Development Facilitation Team (DFT) – Review Comments

Project No: PR-2022-007103 Date: 07/10/2024 Agenda Item: #1 Zone Atlas Page: M-14

Request: Final EPC sign-off for Love's Sunport development, Loves Travel Center

Application For: SI-2024-00922 – EPC FINAL SIGN-OFF

LIGHT POLE DETAIL
N/C

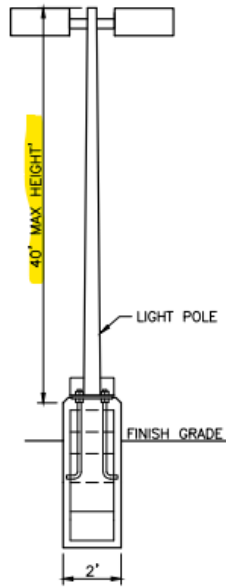
6. Light poles are limited in height to 30 feet in the (non-residential zone districts (NR-LM), as per IDO 5-8(D)(3), Table 5-8-1. Please correct note on sheet SP-2, Travel Center Site Plan, and related detail plans on sheet DET-1.

1 – AREA LIGHT SHALL BE FULLY SHIELDED AND MAXIMUM
35 FT HEIGHT

SHEET DET-1: See excerpt from details shown on next page, indicating height of 40 feet.

light pole callout revised to reflect 30' max height on plan and detail sheet DET-1

light pole callout revised to reflect 30' max height on plan and detail sheet DET-1

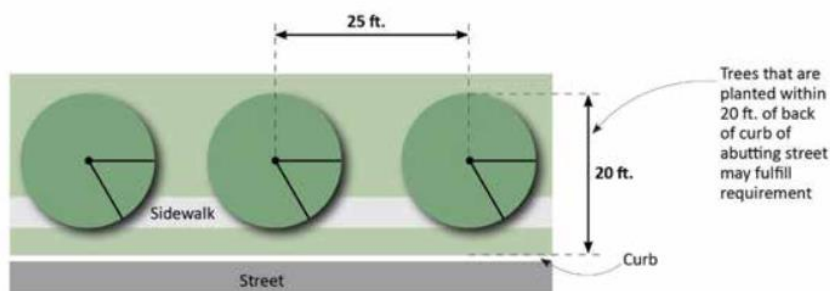
Is Keyed Note #37 intended to be a trail in lieu of sidewalk? If so, please change the name to reflect the intent. An 8' asphalt trail is not preferred for multi-use trail (Bicycles and Pedestrians) per the DPM and would not be maintained by the Parks and Recreation Department. A note on the infrastructure list and DRC plans will need to indicate this and that the trail will be maintained by the property owner. **Yes. trail is in lieu of sidewalk. Call out modified and to reflect 8' Asphalt Trail (to be maintained by property owner**

If the intent is for a paved multi-use trail, then the trail will need to be 10 ft wide and built per the DPM for a multi-use trail. Proposed multi-use trail is indicated in this area, but not specifically along Broadway Blvd SE. Please contact Whitney Phelan if you have additional questions.

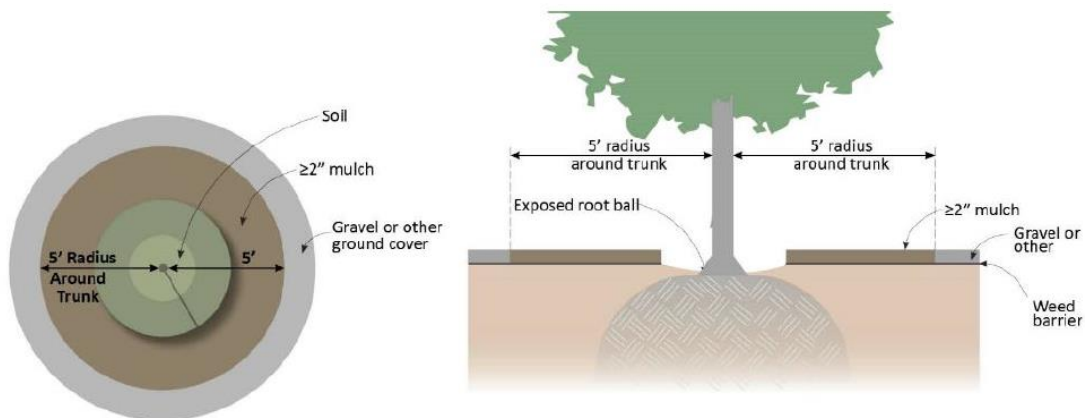
- Per 5-6(C)(5)(e), **organic mulch** is required as ground cover under trees within a 5- foot radius around the tree trunk, but not directly against the trunk. In these areas, weed barrier fabric is prohibited. (See figure below.)

- **Provide a tree planting detail to reflect this requirement.** The organic mulch used under the trees can be counted towards non gravel mulch used on the site as discussed earlier under 5-6(C)(5)(c). **Please make sure you are mention 'Organic Mulch' or arborist mulch on your planting details.**

Detail Provided

Gravel Mulch proposed

Landscape Architect to coordinate addressing comments directly with COA prior to DFT hearing
